REPORT TO: Committee of Adjustment

REPORT NO.: DSD-2025-149

SUBJECT: Minor Variance Application A2024-033 – 887 Frederick Street

Figure 3: The proposed site plan with the variances labelled

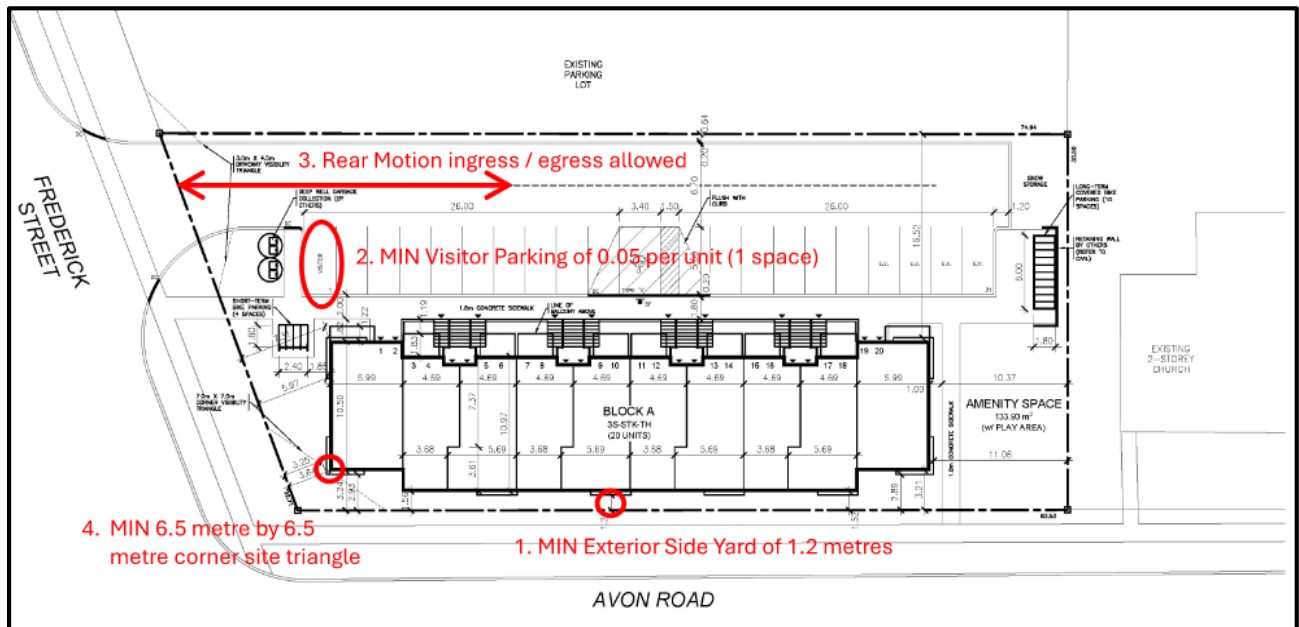
- To have the garbage or loading truck leave the site in a backward motion.
- To have a reduced exterior side yard setback of 1.2 metres instead of 3.0 metres.
- To have the visitor parking reduced to 1 instead of 3 visitor parking spaces required.

Due to the narrow configuration of the site, it is constrained in a way that makes it impractical to provide forward ingress and egress for a standard garbage truck. As such, the garbage truck will be the only vehicle required to exit the site in reverse. To address this, the proposal incorporates the following mitigation measures to maintain the intent of the zoning regulation:

The proposed design provides a minimum exterior side yard of 1.24 metres at its closest point, where above-grade walls with overhangs are present. The remainder of the wall along the exterior yard is set back approximately 1.5 metres from the lot line, with the front and rear portions of the building stepped back to approximately 3.0 metres. These setbacks help to improve building articulation, create a transition to the public sidewalk, and ensure better alignment with the established neighbourhood character.

While each dwelling unit is provided with one dedicated parking space, meeting the minimum parking requirement for each dwelling, the proposal includes one visitor parking space, resulting in a shortfall of two visitor spaces.

1. That a note be provided on the Site Plan that garbage pick-up will occur during off-peak hours (9:30 a.m. to 3:30 p.m.) Monday to Friday.

Figure 6: The side elevation corner with the reduced overhead for the CVT

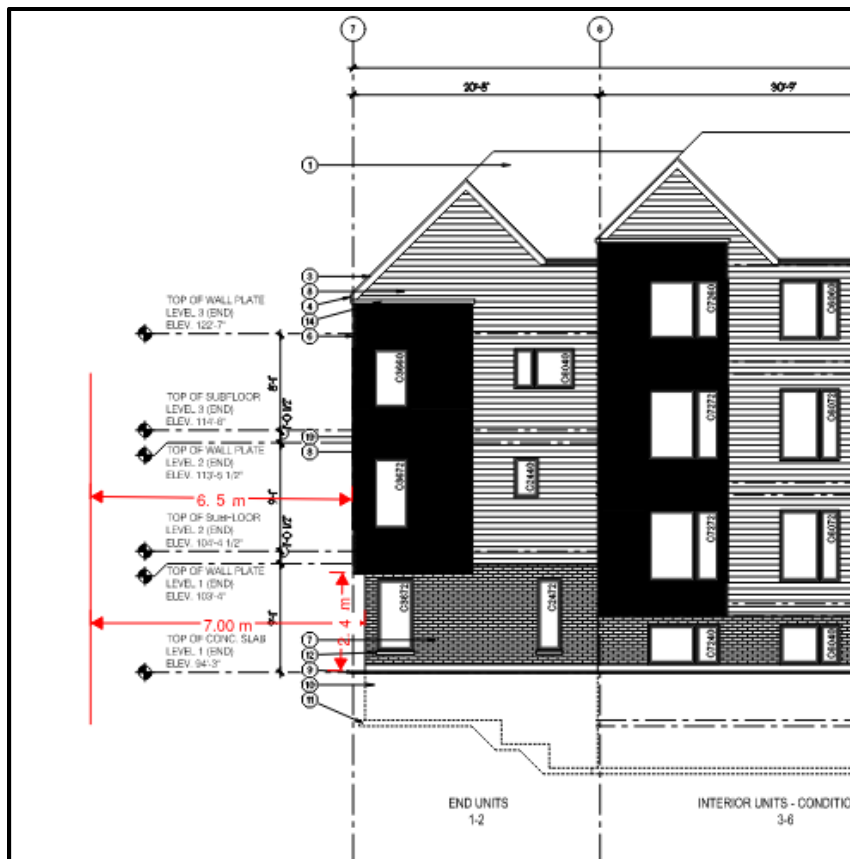
Corner Visibility Triangle (CVT): The CVT intends to ensure safe sightlines at intersections for drivers, cyclists, and pedestrians. The proposal provides 7 metres from the point of intersection of the street lines but with an increased overhead vertical clearance above 0.9 metres. The building has a projection that obstructs the overhead clearance of 2.4 metres, as shown in Figure 6. The 2.4 metre clearance exceeds the typical head-height clearance for a regular vehicle, as shown in Figure 7, making obstruction unlikely. This is because the intersection at Frederick and Avon Road is not considered a busy intersection for larger trucks, as Avon Road is a local street with less traffic.

Additionally, the subject property is located at an intersection with an obtuse angle, which naturally provides more expansive and improved sightlines compared to a standard 90-degree corner. This geometry enhances the overall visibility for drivers, cyclists, and pedestrians approaching the intersection.

Corner Visibility Triangle: The requested variance for the vertical clearance within the corner visibility triangle is considered minor. A clearance height of **2.4 metres** accommodates most vehicles on Avon Road, maintaining safe sightlines for drivers and pedestrians.
